**BOROUGH OF HIGHLANDS
LAND USE BOARD MEETING**
151 Navesink Ave. - Court Room
Thursday, May 09, 2024 at 7:00 PM

3. LUB2022-06: Martin, 15 Barberie Ave, B77 L15 - Extension Request
4. LUB2022-10: Home & Land - 14 & 32 North Peak, B35 Ls 8 & 9

**MINOR SUBDIVISION OF
LOTS 8, 9 ~ BLOCK 35**
32 & 14 North Peak Street
Borough of Highlands
Monmouth County, New Jersey

DATE: 04-05-2024 SCALE: AS SHOWN DRAWN: AJC CHECKED: FF SHEET: 4 OF 6 JOB: PR-0290

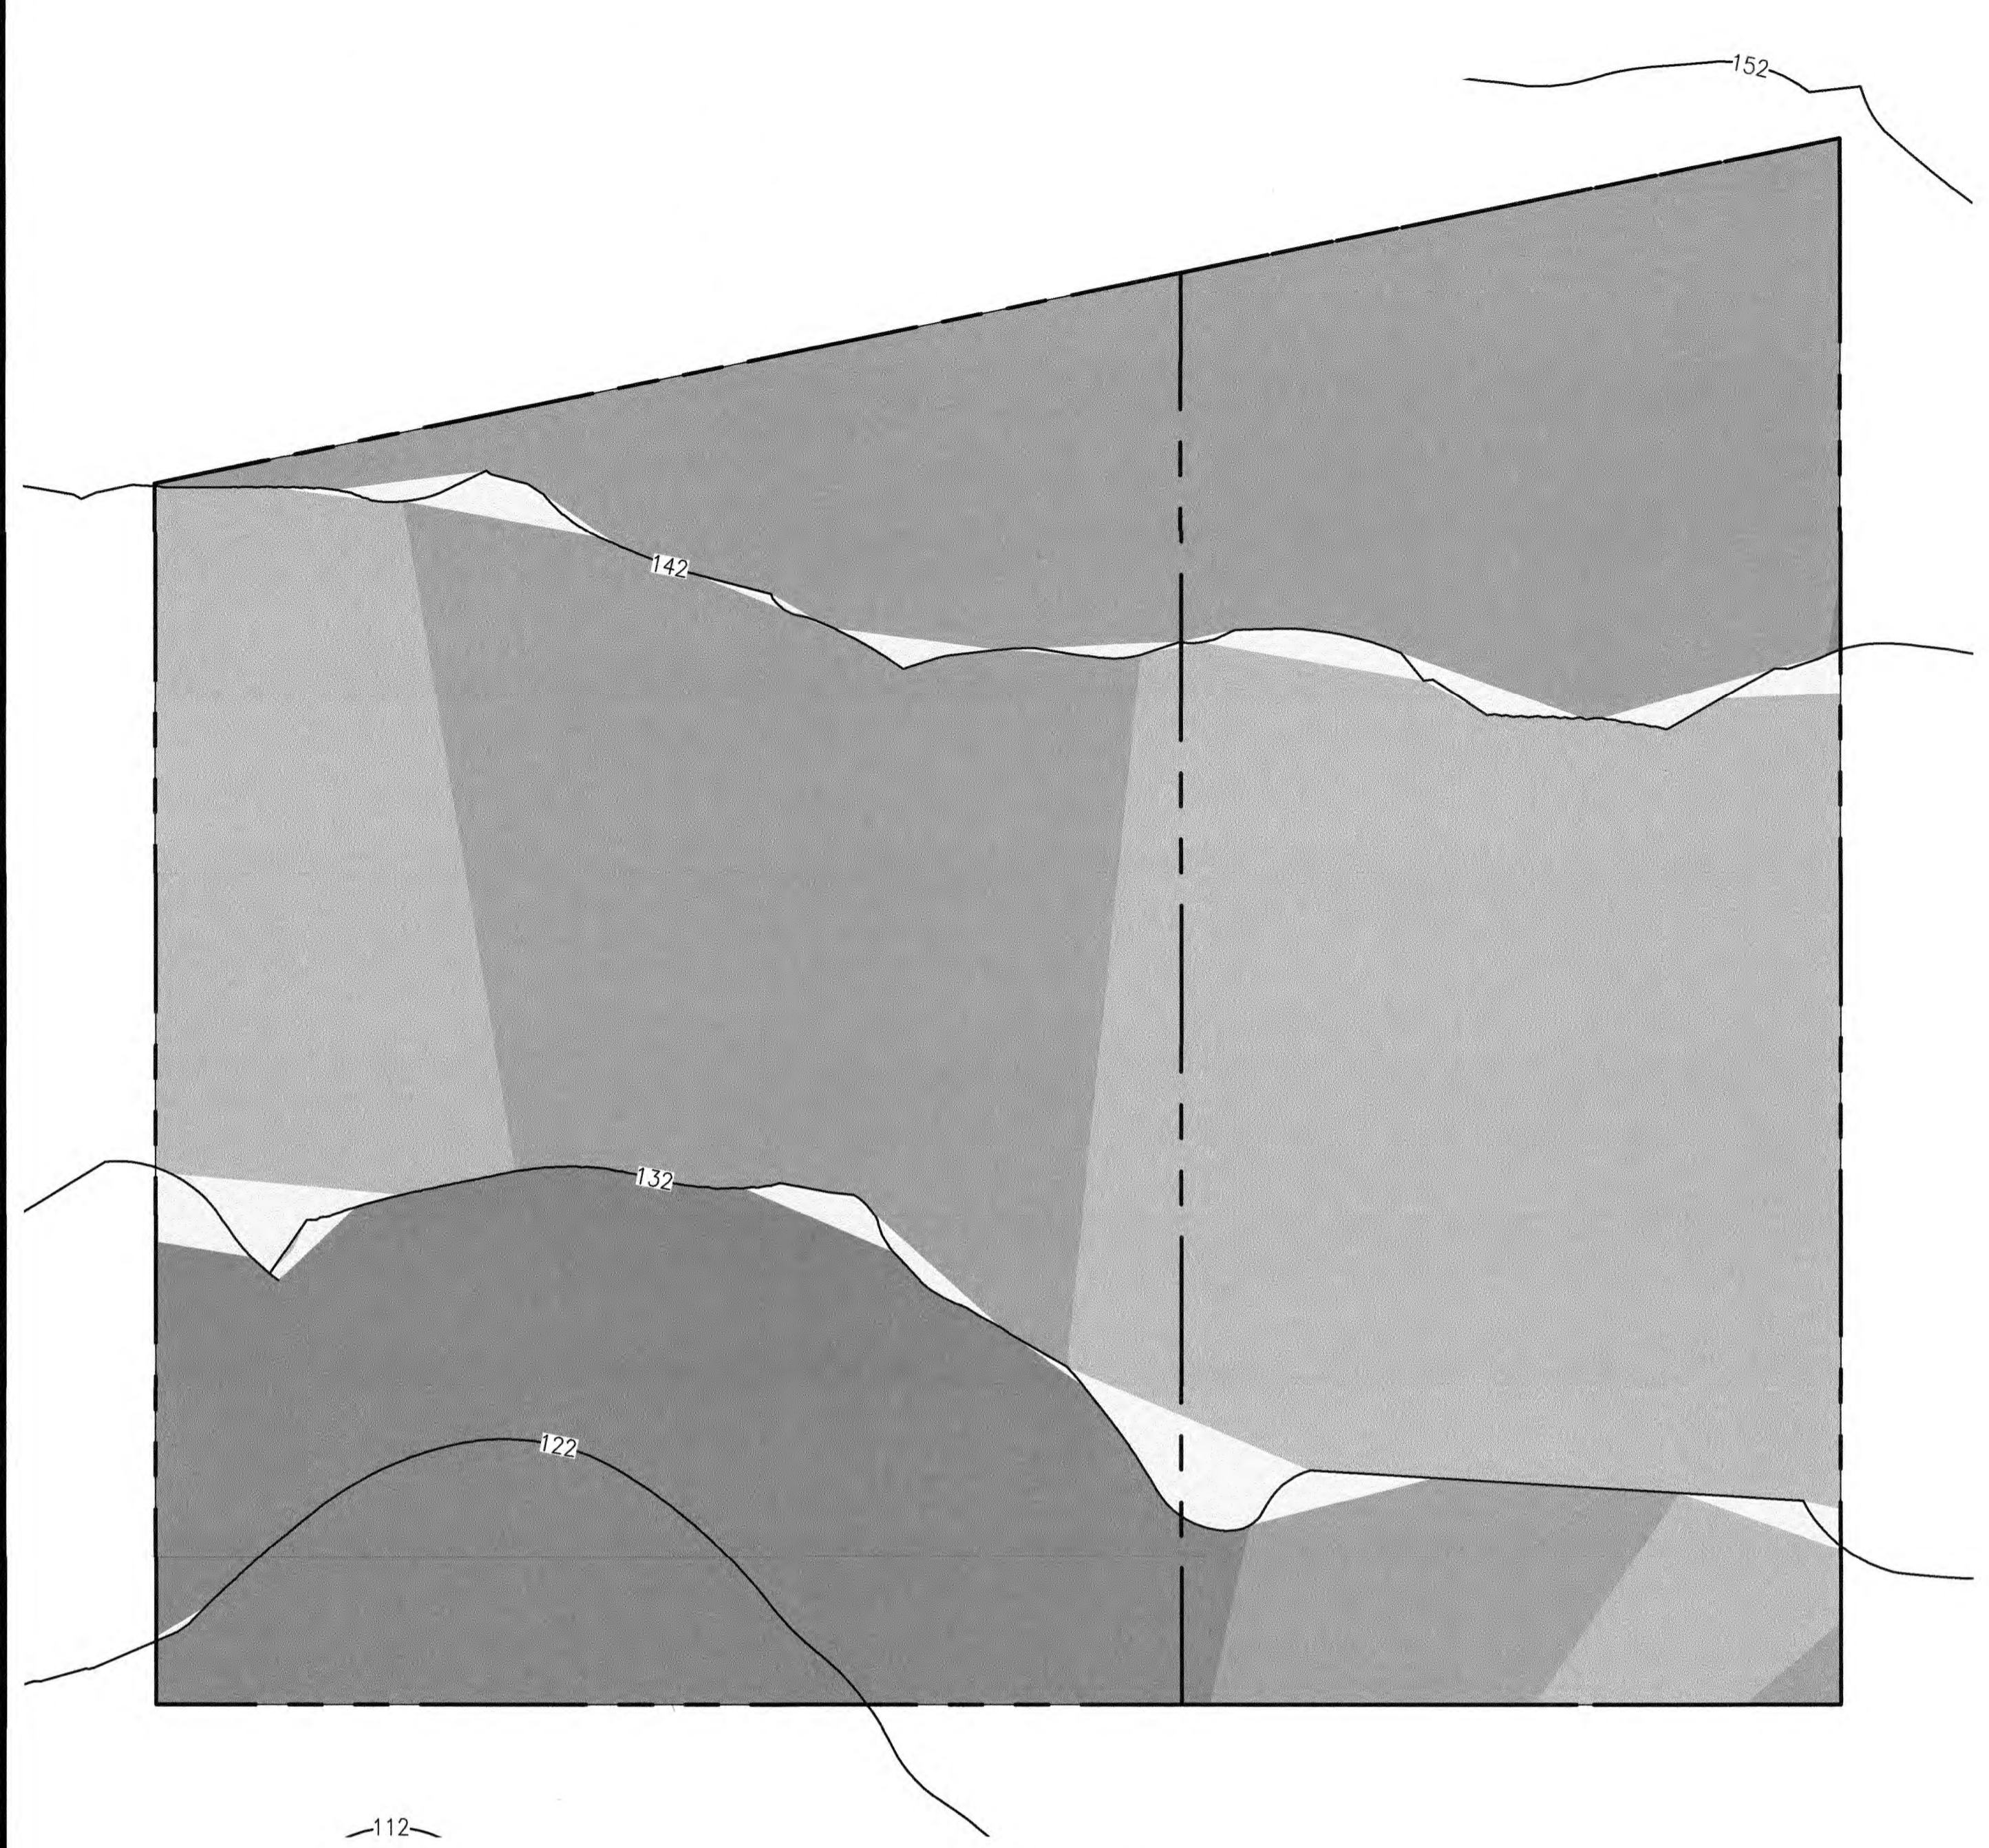
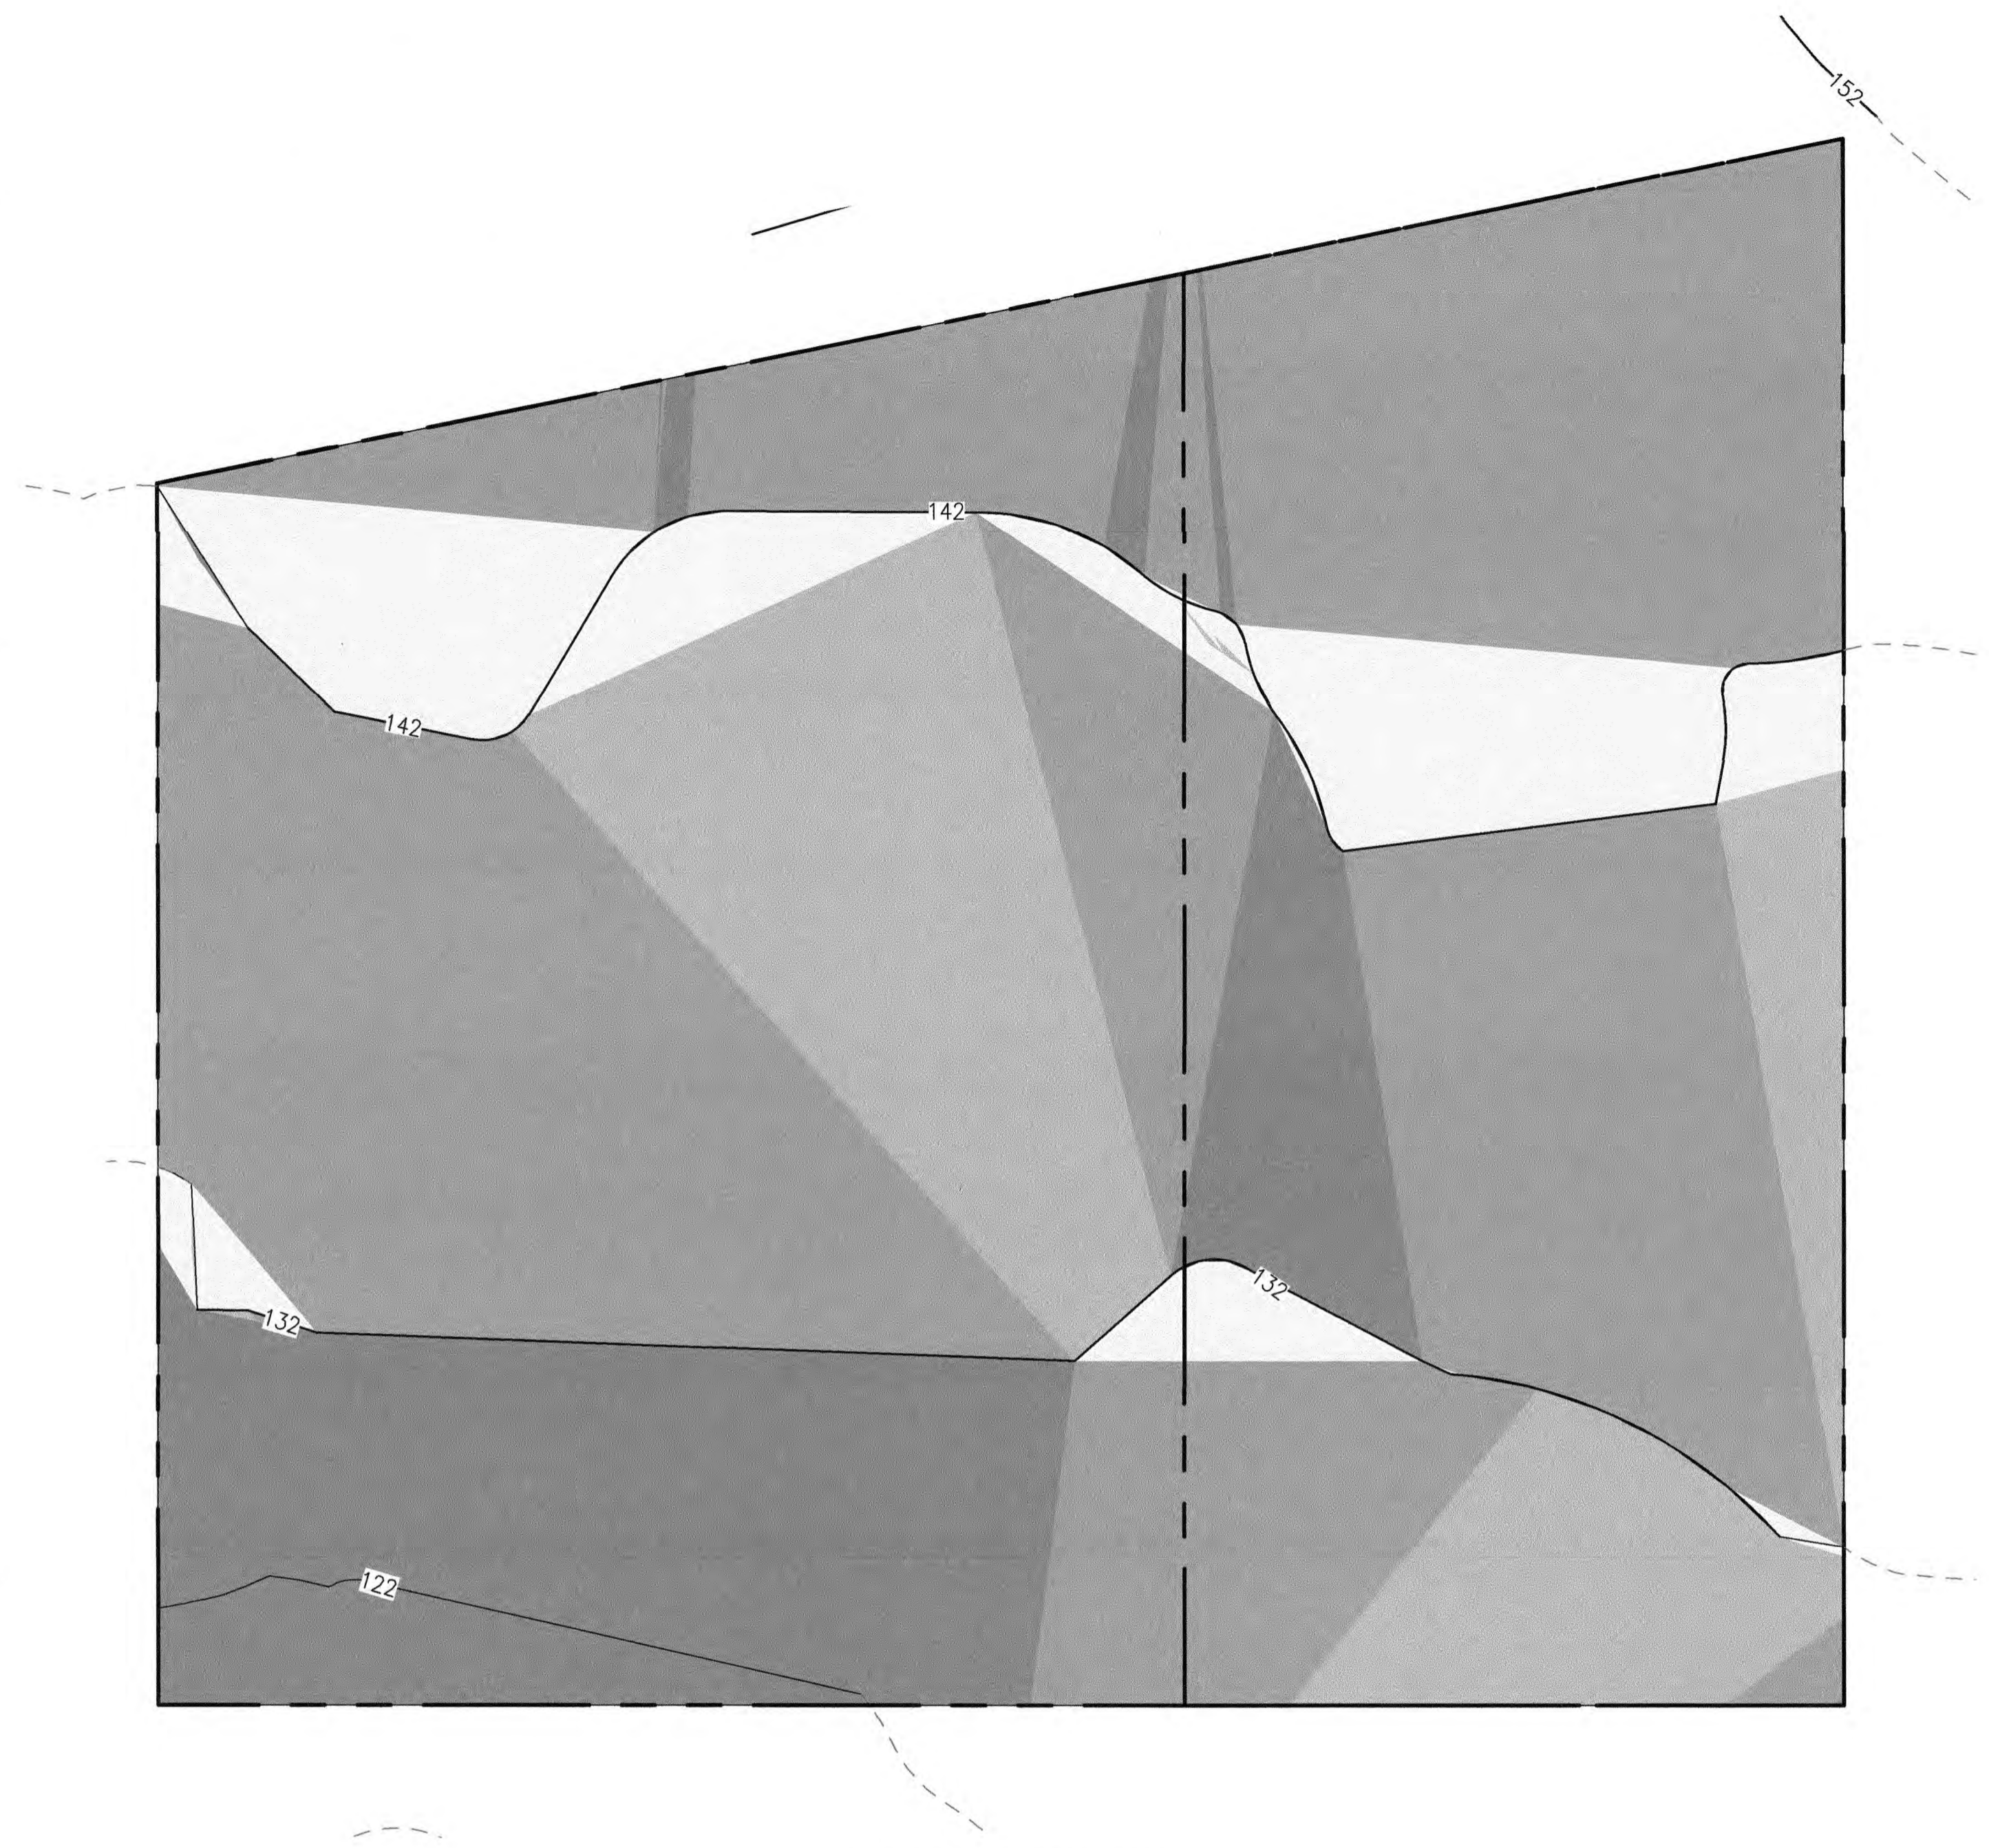
The Applicant is requested to provide a slope area calculation table noting existing and proposed areas of slopes per criteria. The analysis for the Slope Ordinance not only pertains to the subject property but also 100 ft from the boundary of the property. There are slopes greater than 15% as shown on Sheet 2 and the proposed front yard grading on Sheet 3.

This office has prepared a slope analysis plan, see sheet 5 of 8. Additionally, Stormtech (SC-740) Chamber Systems will be installed in the rear yards of each property. The chambers will temporarily store roof runoff during a storm event to control the stormwater runoff. The bottom of the chambers are open and are installed on clean stone which allows the stored water to percolate into the ground. Roof leaders will be hard piped directly to the chambers. Details, size, and specification may be provided upon request.
